SERVICE BULLETIN

NUMBER: 16-112-18R

SUBJECT: Ignition Key Sticking / Design Change to CVT Shifter / Selector Lever Components / **Parking Brake Switch Warranty Extension**

For Legacy and Outback:

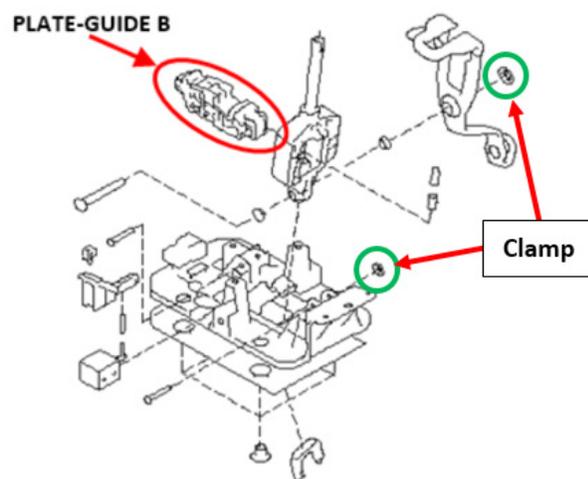
- The term PLATE-GUIDE B refers to the Park-Range switch which is a serviceable part of the select lever assembly on all models listed above **EXCEPT** Legacy and Outback. See the illustrations provided below for more details.

- For **Legacy and Outback**, the shifter assembly (SELECT LEVER COMPLETE) must be replaced if the Park-Range switch is found to be faulty.

Description	Part Number	Applicability
PLATE-GUIDE B	35122FJ033	2012-2016MY Impreza
		2013-2017MY Crosstrek
		2014-2018MY Forester
		2015-2018MY WRX
	35122AJ162	2018MY Crosstrek
	35122FL00B	2017-2018MY Impreza
CLAMP	35164AJ000	1-Time Use items, must be replaced whenever installing PLATE-GUIDE B on above models, 1 of each required.
	35164AJ010	
SELECT LEVER COMPLETE	35111AL00B	2015-2017MY Legacy & Outback

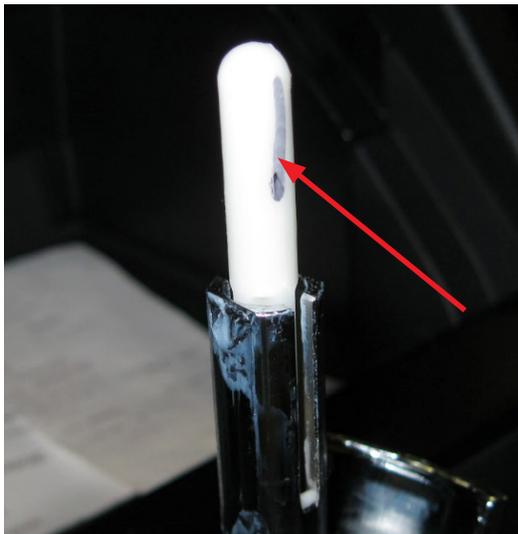
IMPORTANT TIP: After removing the shift knob there will be a white plastic rod / plunger protruding from the top of the chrome lever. Use a permanent marker and mark its position as shown in the photo so it can be put back in the same place during reassembly. The bottom end has a notch in it which **must** be in the correct position for proper operation of the mechanism.
